Gulfstream American

SERVICE BULLETIN NO. 168

SUBJECT: AILERON TORQUE TUBE JOINT INSPECTION

SERIALS AFFECTED: All AA5A and AA5B aircraft equipped with Service Kit SK 150 modified ailerons. All AA5 aircraft equipped with Service Kit SK 150 modified ailerons and the 5202035-505 aileron torque tube assembly.

FIGURE 1

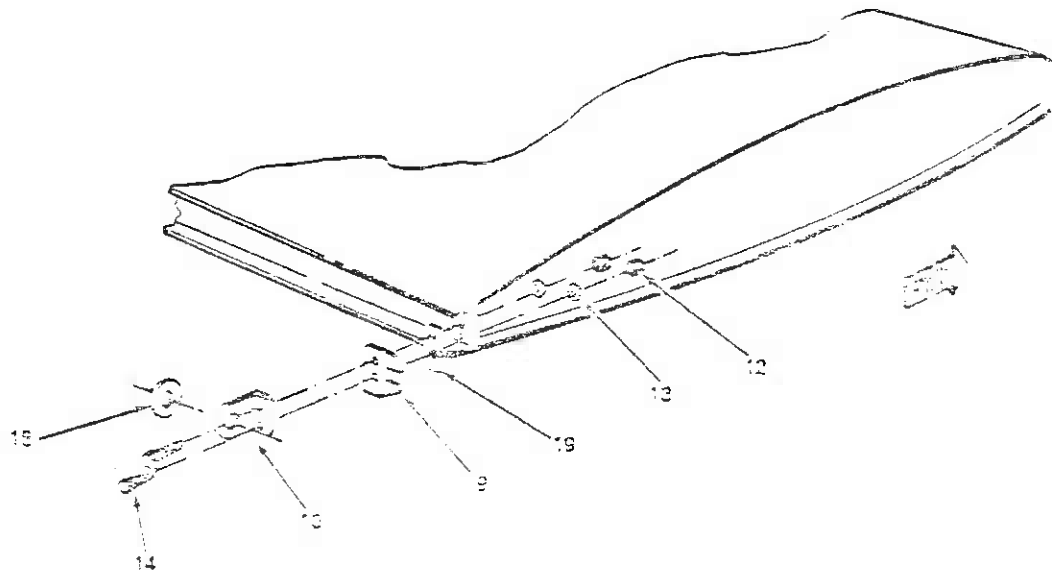
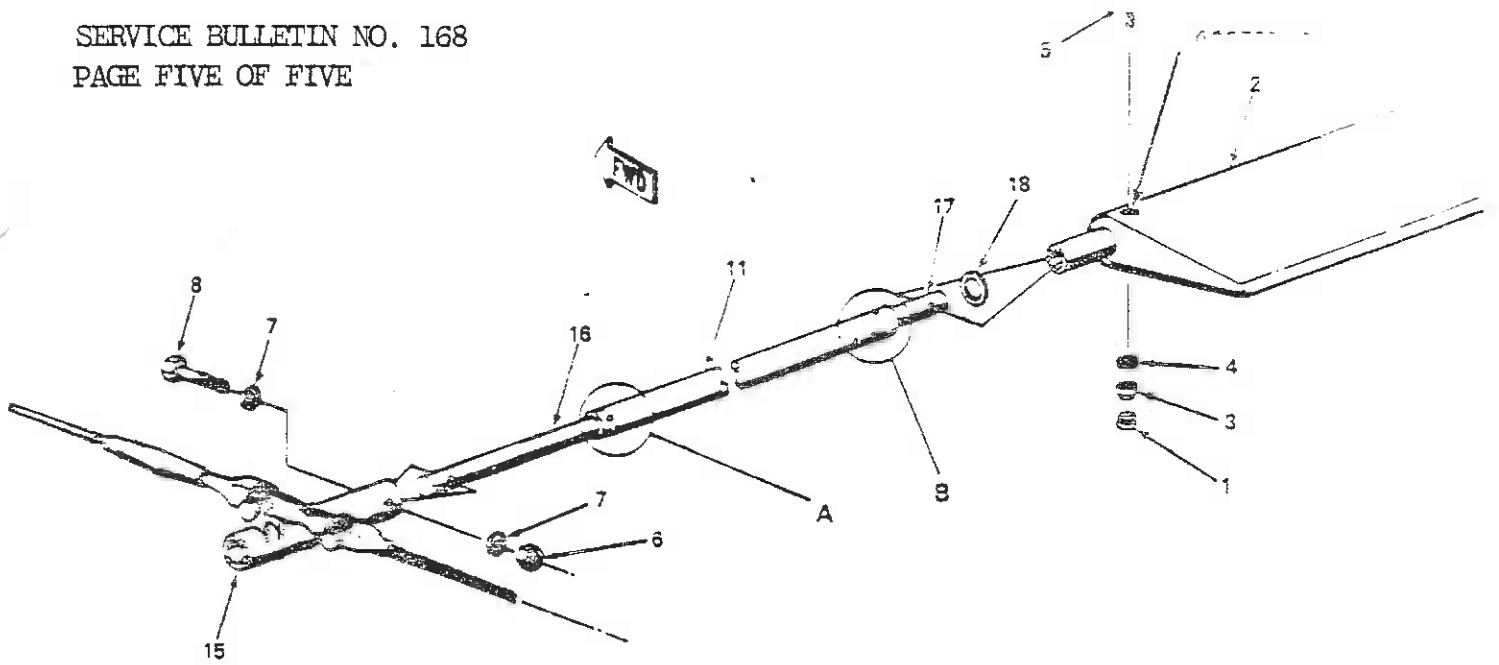
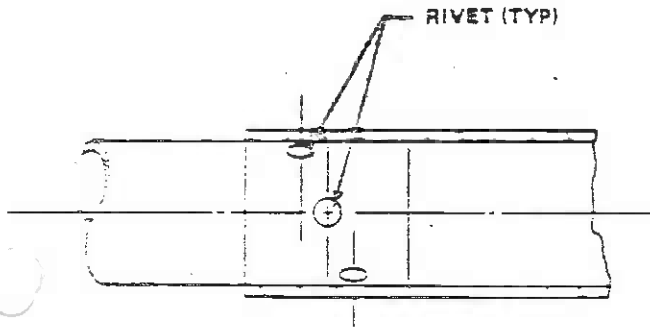
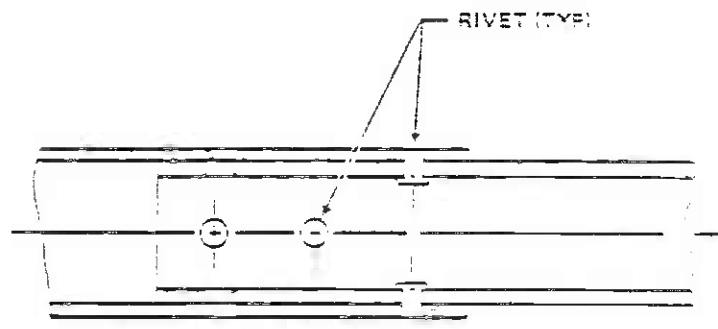
This Service Bulletin is directed at those aircraft (AA5A and AA5B) with ailerons modified by Service Kit SK 150, and all AA5 aircraft with ailerons modified by Service Kit SK 150 and the 5202035-505 aileron torque tube assembly. Referring to Figure One (1), the aileron torque tube assembly requiring inspection consists of a tube, Part No. 5202035-11 (11) an inboard sleeve, Part No. 5202035-6 (16), and an outboard sleeve, Part No. 5202035-11 (17).

- (1) Inspect both inboard and outboard torque tube joints for looseness.
- (2) If joints are loose, joints will have to be reworked as per instructions in Service Kit SK 144.
- (3) Upon completion of inspection and, if necessary, modification torque tube can be returned to service.

- A.) Aileron/torque tube removal (REFER TO FIGURE 1)
- (1) Remove wing tip as described in Chapter 57 of AA-5 series Maintenance Manual.
 - (2) Remove plugs (1) from inboard end of aileron (2). Remove nut, (3), washer (4), and bolt (5).
 - (3) Remove nuts, (12), washers (13), and bolts (14) from wing. Note installation, if installed, of spacers (18) and shims (19). Mark position of control stop (9) and aileron hinge (10), then remove from wing. Disconnect ground terminal.

- (4) Pull aileron outboard in order to remove from inner torque tube assembly.
- (5) Remove interior trim per Chapter 25 of AA-5 series Maintenance Manual to gain access to the aileron control horn.
- (6) Remove nut (6) and washer (7) from bolt (8) which secures control horn (15) to torque tube assembly. Remove bolt.
- (7) Pull aileron torque tube assembly outboard to remove it from the aircraft.

- (1) Slide aileron torque tube through flap until it extends into the fuselage.
- (2) Position torque tube assembly in control horn (15) until the holes align.
- (3) Secure with bolt (8), washers (7), and nut (6).
- (4) Insure that spacer (18) on inboard end is reinstalled as noted during removal. Slide aileron on to torque tube sleeve (17) until attach hole aligns.

- (5) Secure with bolt (5), washer (4), and nut (3).
Install plugs (1).
- (6) Insure that spacer (18) on outboard end of aileron and shim (19) are reinstalled as noted during removal. Position aileron hinge (10) and control stop (9) as marked during removal.
- (7) Secure with bolts (14), washers (13), and nuts (12).
Connect ground terminal.
- (8) Check aileron rigging and adjust as required as described in Chapter 27 of AA-5 Maintenance Manual.
- (9) Install wing tip as described in Chapter 57 of AA-5 series Maintenance Manual.
- (10) Install interior trim as described in Chapter 25 of AA-5 series Maintenance Manual.
